# Agenda

## Reliability and Security Technical Committee

December 15, 2021 | 11:00 a.m.–4:30 p.m. Eastern Time

**Figure I.1: Logic Diagram of Generic UFLS Schemes**

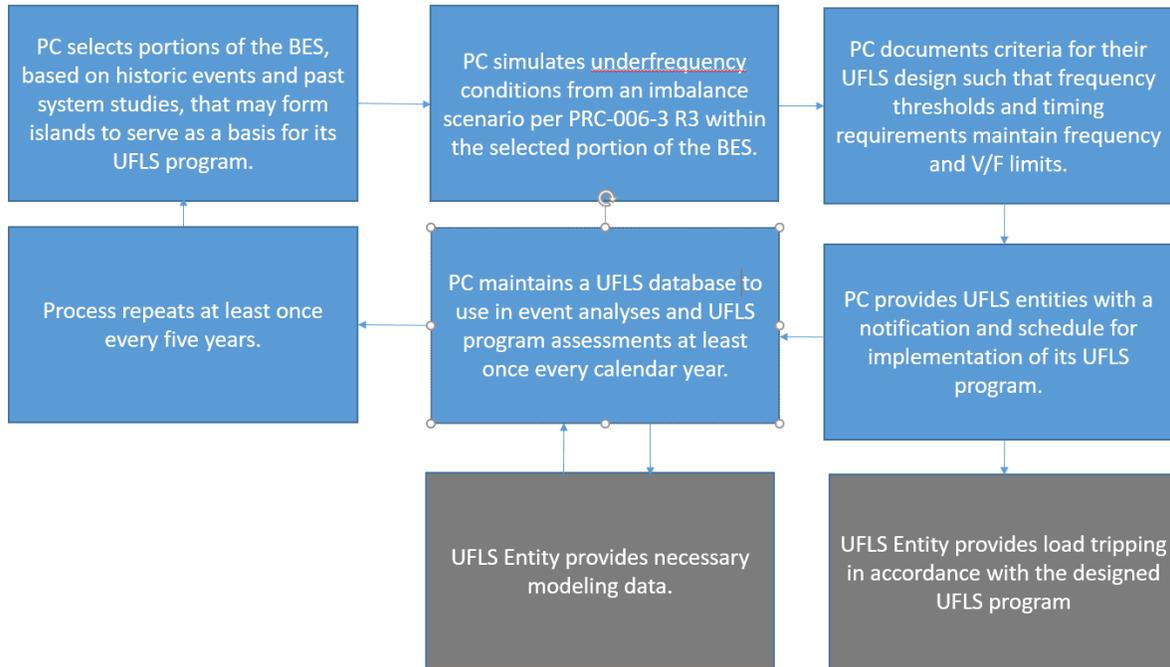
Eastern Interconnection Planning Collaborative - Frequency Response Working Group (FRWG)	9	Figure I.1 middle blue box:	the words do not flow well "in order to use in event...",
Eastern Interconnection Planning Collaborative - Frequency Response Working Group (FRWG)	9	Line 189	The descriptors in this sentence seem to be in conflict.
Eastern Interconnection Planning Collaborative - Frequency Response Working Group (FRWG)	9	Lines 825-828	describes adaptive UFLS programs as a potential solution to high penetrations of DER. This is where you shed certain loads based on DER output conditions – it could be different for different times of day depending on DER output.

**Figure 1.1: UFLS Program Design Changes Based on DER**

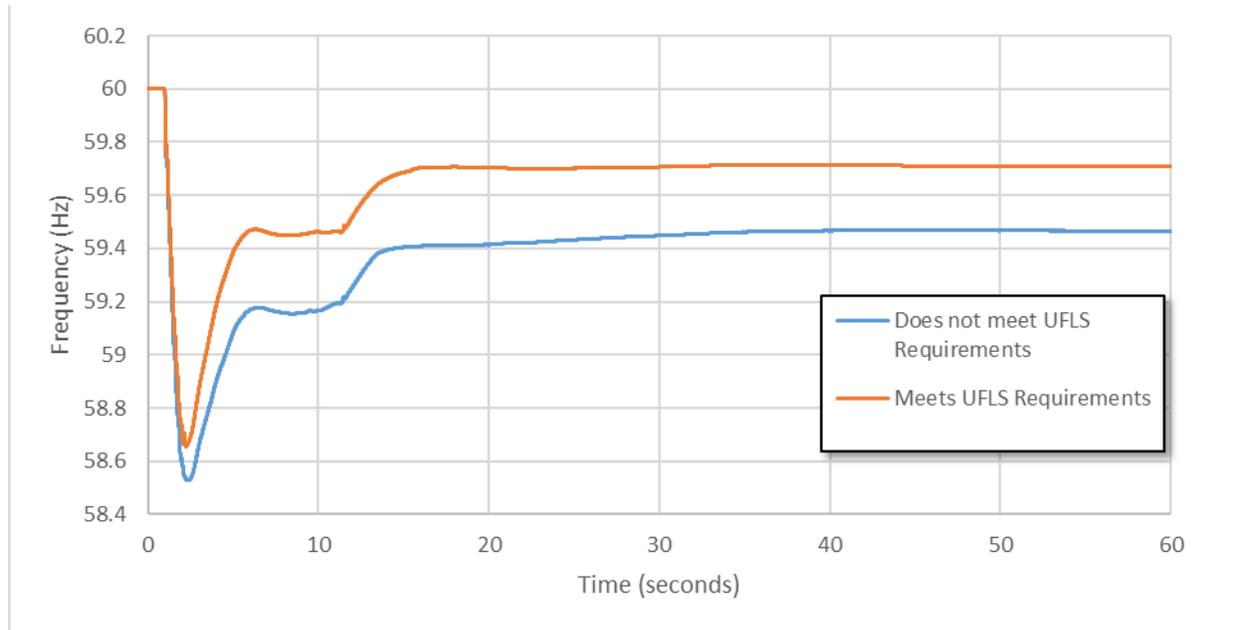
Eastern Interconnection Planning Collaborative - Frequency Response Working Group (FRWG)	13	Lines 285-288	These statements contradict of the statements in Figure 1.1. Figure 1.1 shows that the blue line did not meet the UFLS criteria, while the orange line did meet the UFLS criteria.
Eastern Interconnection Planning Collaborative - Frequency Response Working Group (FRWG)	14	line 285-288:	The language says that orange line does NOT meet criteria, however in the Figure 1.1, it says orange line meets the criteria and blue line does not meet the criteria.
Eastern Interconnection Planning Collaborative - Frequency Response Working Group (FRWG)	15	Key Takeaway in blue box:	the first sentence appears to have repeated "BPS" and does not read well.

**Figure 1.2: Impact of Increasing DER tripping from UFLS Action on Island Frequency Performance**

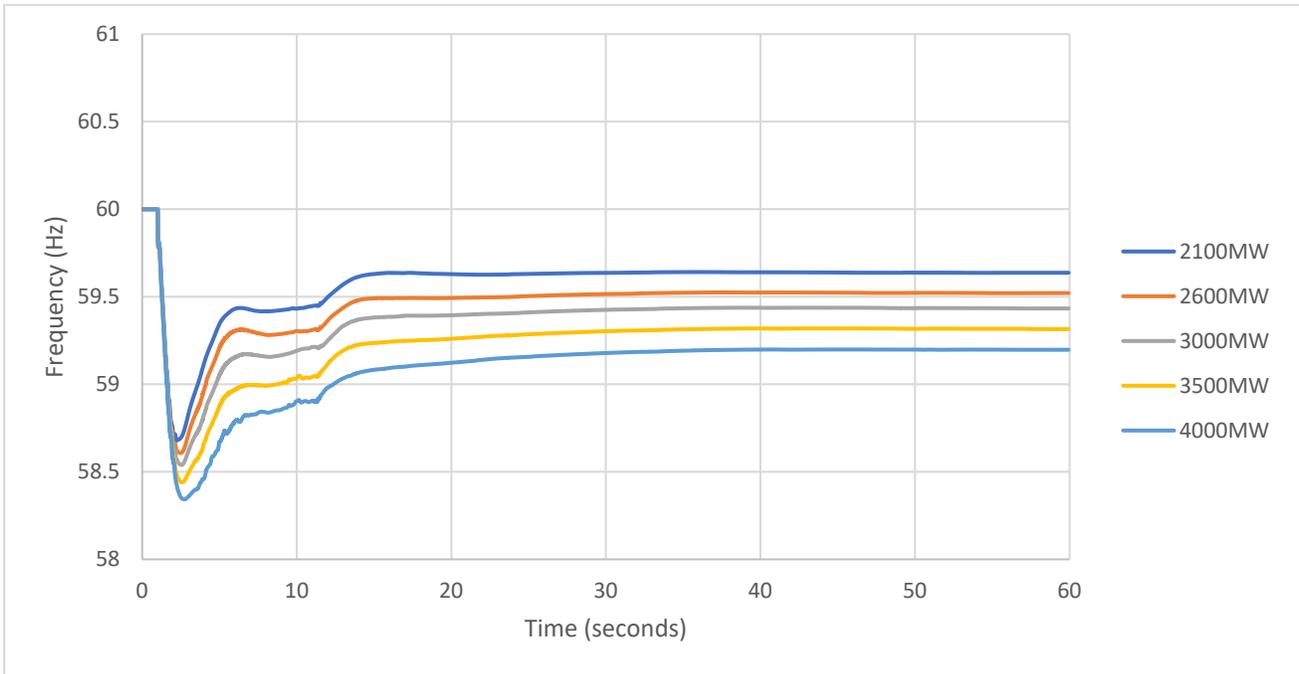
ISO New England	4	332	Figure 1.3 does not show a 5 second window
ISO New England	3	337	Figure 1.2 needs to have labels for each axis
ISO New England	4	340	Figure 1.3 needs to have labels for each axis

**Figure 1.4: DER Tripping from Voltage Fluctuations after UFLS Actions.**

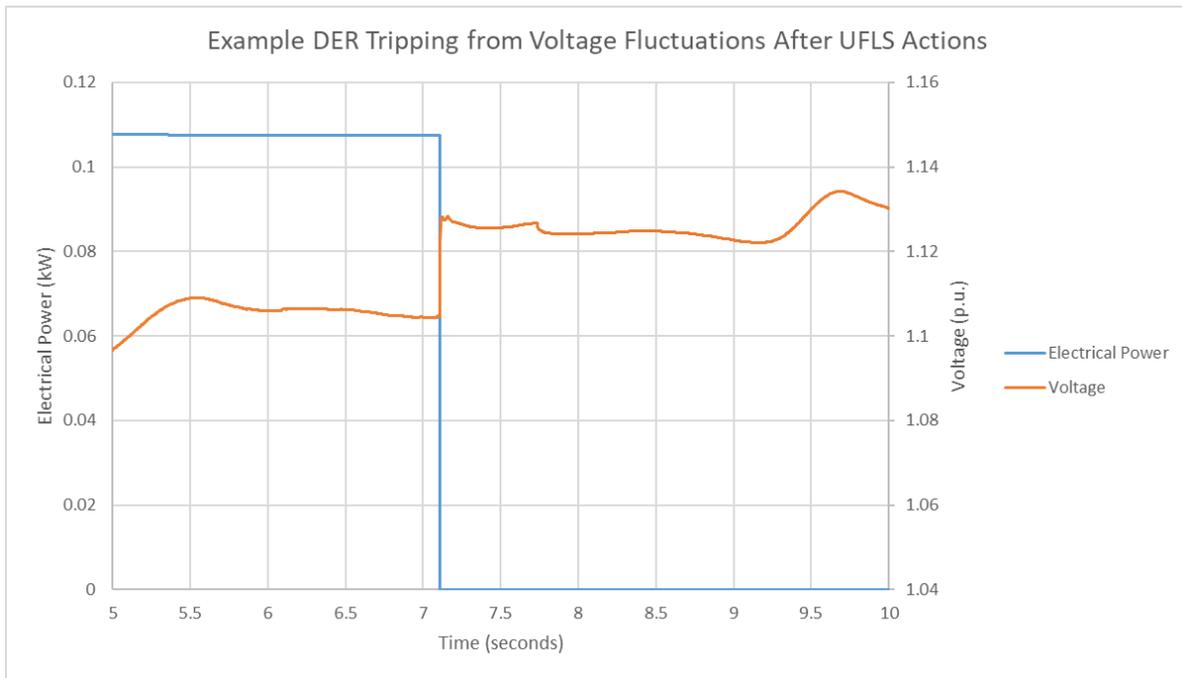
Eastern Interconnection Planning Collaborative - Frequency Response Working Group (FRWG)	17	figure 1.4 :	there are two vertical axis without labels. Additionally a legend describing the two curves depicted is needed to avoid having to assume their meaning.
Eastern Interconnection Planning Collaborative - Frequency Response Working Group (FRWG)	17	line 370:	"increasing penetrations of legacy inverters" seems counterintuitive. Are "legacy inverters" increasingly being added to the system?
Eastern Interconnection Planning Collaborative - Frequency Response Working Group (FRWG)	17	Line 385	Older, legacy DERs that are subject to early versions of IEEE 1547 may have a propensity to trip at frequencies closer to nominal while newer DERs compliant IEEE 1547-2018.29
Eastern Interconnection Planning Collaborative - Frequency Response Working Group (FRWG)	18	lines 414:	The language is missing something,

SCS - Transmission Planning Department - SME/Team Lead - Jennifer Bell	Page 17	figure 1.4 :	there are two vertical axis without labels. Additionally a legend describing the two curves depicted is needed to avoid having to assume their meaning.
SCS - Transmission Planning Department - SME/Team Lead - Jennifer Bell	Page 21	line 501:	change PRC-006-3 to PRC-006-5.
SCS - Transmission Planning Department - SME/Team Lead - Jennifer Bell	Page 21	lines 495-525:	<p>Some consideration should be given to the fact that UFLS schemes were never intended to be load-level matched balancing schemes but rather a safety net to help avoid frequency declining low enough to cause more generation to trip offline which could cascade into a blackout. When considering DER impact to UFLS design, some deference should be given to understand the UFLS scheme is designed to be very conservative, in that the design requirement includes a large 25% load/generation imbalance as a design basis. This conservatively large imbalance was intended to account for load variation which occurs through all periods of the year, fully recognizing that it may not be capable of performing at the same level for all time periods, but should be able to perform sufficiently well to avoid cascading for most realistic generation loss events. Additionally, adaptive control schemes introduce added complexity and cyber vulnerabilities that come with widespread coordinated control. A better approach would be to consider the protection settings of the generation and load connected to the system. As synchronous machines are replaced with inverter-based resources, consideration should be given to whether the current level of performance required for UFLS design should be adapted to account for IBR ability to ride through much lower frequency excursions. Why not consider extending (widening) the frequency performance envelopes used in the design of UFLS schemes?</p>

update link for IEEE Power & Energy Society Technical Report	Change made based on proposed edit.
Alternatively, more UFLS tripping is not an acceptable option from a reliability perspectives, as the system undergoes continual change in terms of its generation mix.	Change made as proposed
Looking at the first few seconds of the same comparison in Figure 1.3, the recovery of the island frequency is also shown to be much slower with the increase of DER behind UFLS feeders.	Change made as proposed
Add description of axis descriptions. Y = frequency (Hz), X = time (seconds)	Change made as proposed
Add description of axis descriptions. Y = frequency (Hz), X = time (seconds)	Change made as proposed

**Figure B.5 Example of UFLS Operation During a Period with High Distributed PV Generation [Source: AEMO]**

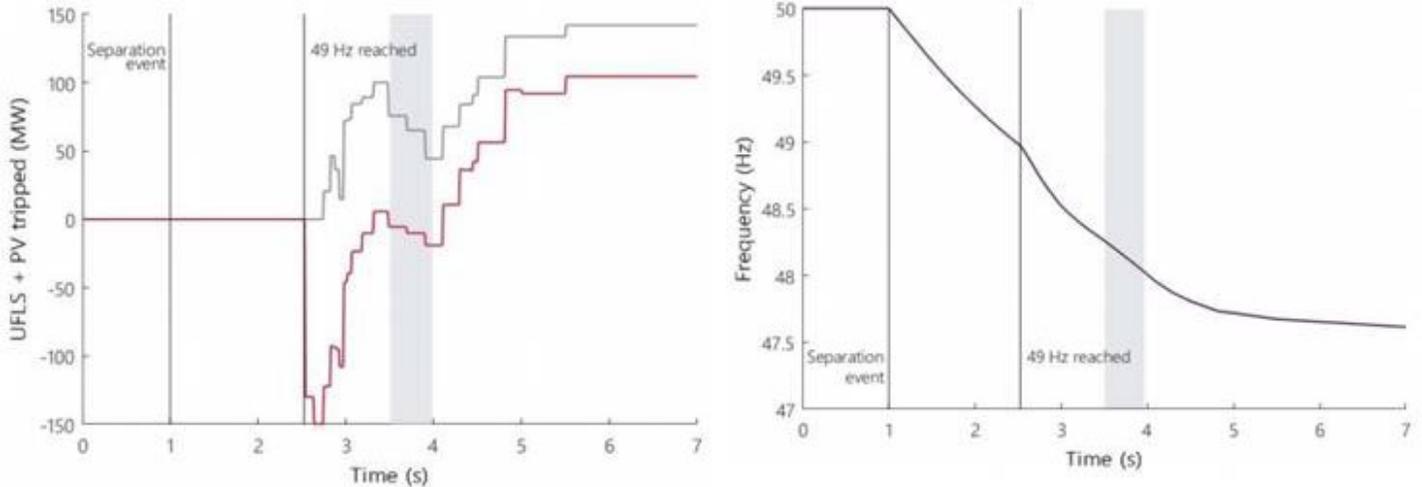
ISO New England	23	1035	In Table A.1, there needs to be a footnote to say that the amount of MW in this row for NPCC is the total TO, DP and DPUF total load. It looks like it is system load
ISO New England	28	1107	Figure B.5 doesn't seem to be discussed anywhere in the text

Clarity added in new text to state that the imbalance was performed for each case.
DER Tripping on High ROCOF Conditions: During the initial onset of the frequency imbalance, ROFOF within the electrical island may be high, and may lead to tripping.	Change made based on comment.
NPCC*  *NPCC load is based on total TO, DP and DPUF load. Please also note that the Québec Interconnection has five threshold stages and four rate-of-change (slope) stages of load shedding.	Changes made based on proposed edit.
Add description in the text of what Figure B.5 is describing	Changes made based on comment.
